Well Name: COTTON DRAW AJT FEDERAL	Well Location: T24S / R31E / SEC 23 / SENW / 32.203726 / -103.7517556	County or Parish/State: EDDY / NM
Well Number: 2	Type of Well: OIL WELL	Allottee or Tribe Name:
Lease Number: NMNM55947	Unit or CA Name:	Unit or CA Number:
US Well Number: 3001535600	Operator: EOG RESOURCES INCORPORATED

Sundry ID: 2881094

Type of Action: Plug and Abandonment

Cotton Draw AJT Federal #2 – P&A Procedure

**Proposed Wellbore Diagram:**KB: 3579
GL: 356117.500"
13.375" 48.00# @ 900
720 sx = Surface

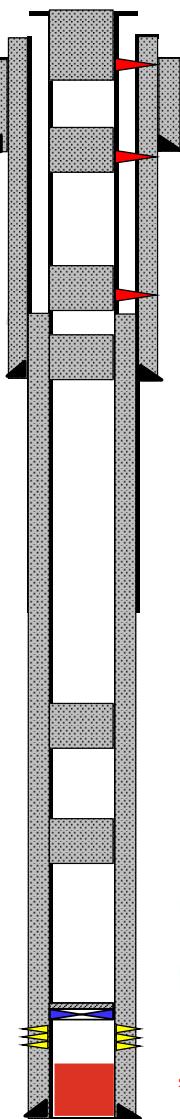
Perf & circulate w/60sx Class C (250-0) Verify at surface- Cap Shoe

Perf & Sqz w/60sx Class C (1058-806) (In 26 sxs/Out 34 sxs) WOC and Tag- TOS & Surf. Shoe

Perf & Sqz w/33sx Class C (3750-3613) WOC and Tag (In 14 sxs/Out 19 sxs)- TOC

Balanced Plug w/32sx Class C (4580-4259) (WOC and Tag)- Bell Formation, Int. Shoes, BOS

Balanced Plug w/25sx Class C (5340-5088) - Cherry Formation

Balanced Plug w/25sx Class C (6618-6366) - Brushy Formation

*Run CBL from CIBP to surface.

Submit results to BLM.

CIBP @ 8130, TAG, Spot 30 sx Class H (8130-7927), WOC, TAG - CIBP rule
Open Perfs 8181-8325

Spot cement from 8555' to 8206'. WOC and Tag, 45 sxs Class H.
